N-series Intel[®] Pentium[®] Processors and Intel[®] Celeron[®] Processors

Specification Update

December 2019

Revision 018

ILB_BASE_ADDRESS Reference: [B:0, D:31, F:0] + 50h

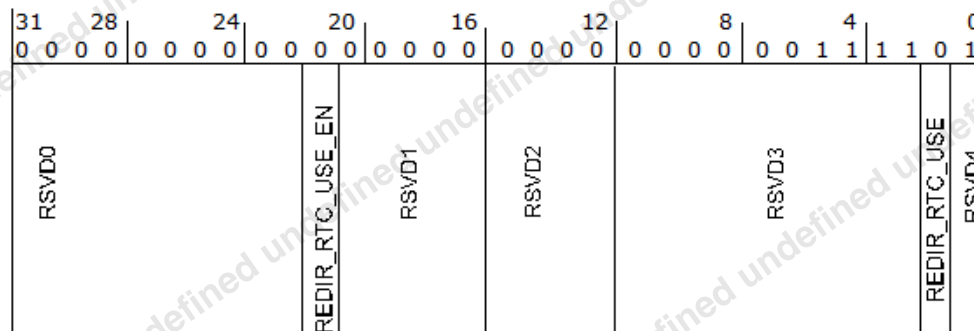
The following register is added to section 33.18 of Datasheet Volume 3. It contains the registers used in the RTC workaround in erratum CHP49.

GPIO Family RCOMP Register

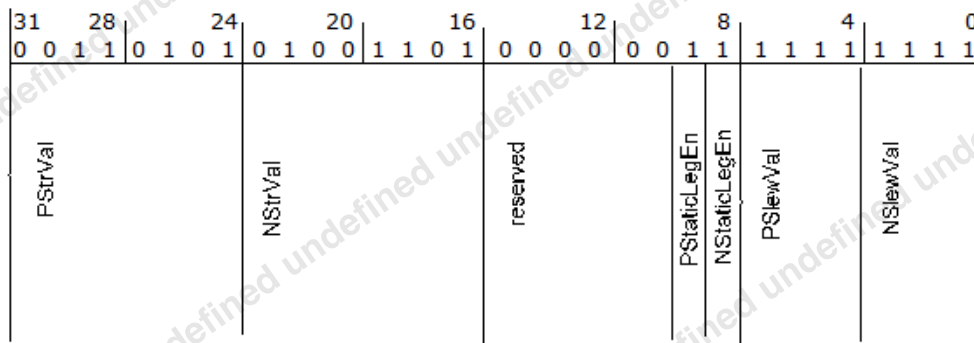
This section provides additional notes to describe the bit range of PSlewVal and NSlewVal in section 33.7.67 Family_config_rcomp_reg (hshvfamily_3x3_rcomp_9_0_family_rcomp_value_reg) - **Offset 1210h**

GPIO Family RCOMP Register

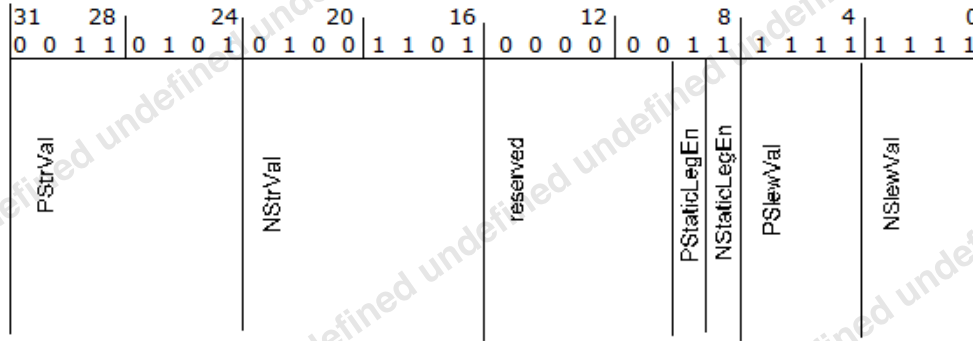
This section provides additional notes to describe the bit range of `PSlewVal` and `NSlewVal` in section 33.7.61 Family_config_rcomp_reg
(`hshvfamily_2x3_rcomp_7_0_family_rcomp_reg`) - **Offset 1190Ch**
